INTERIM AMENDMENT

FEDERAL SPECIFICATION

WIRE TWISTER PLIER (WITH SIDE CUTTER)

The General Services Administration has authorized Federal agencies to use this Interim Amendment as a valid exception to Federal Specification GGG-W-340a, dated March 6, 1963.

FIGURE 1. Pliers, wire twister, with side cutter.

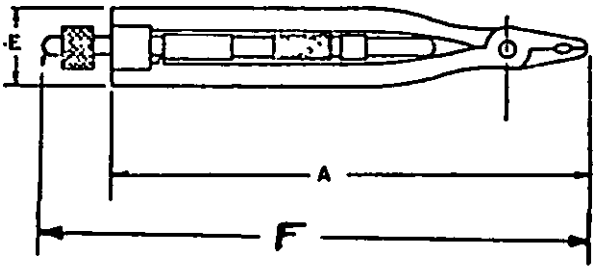
Figure 1: Delete in its entirety and substitute figures 1 and 2.

FIGURE 2. Pliers, wire twister, with side cutter.

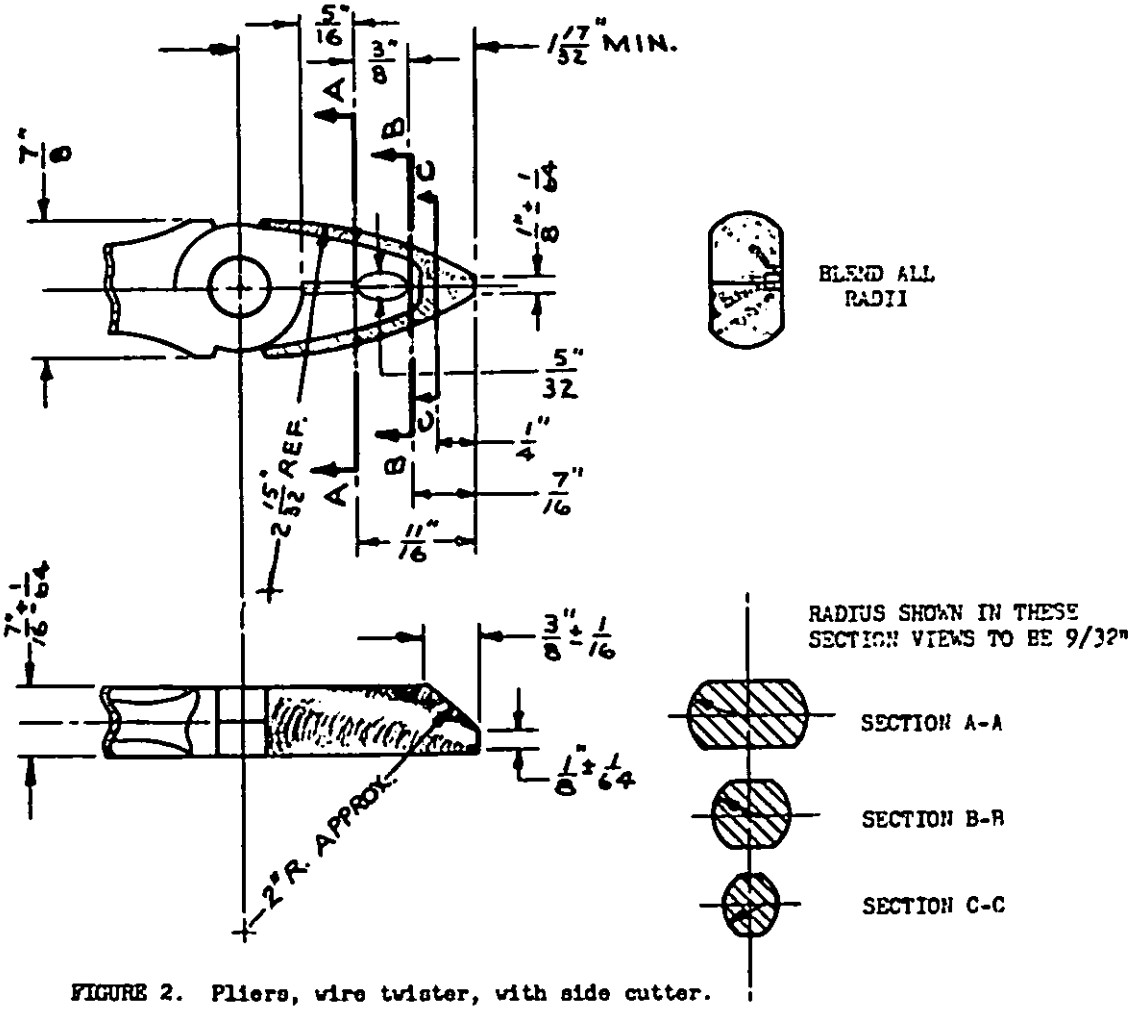
Paragraph 3.10: After "similar to figure 1" add "and meet the dimensional requirements of figure 2."
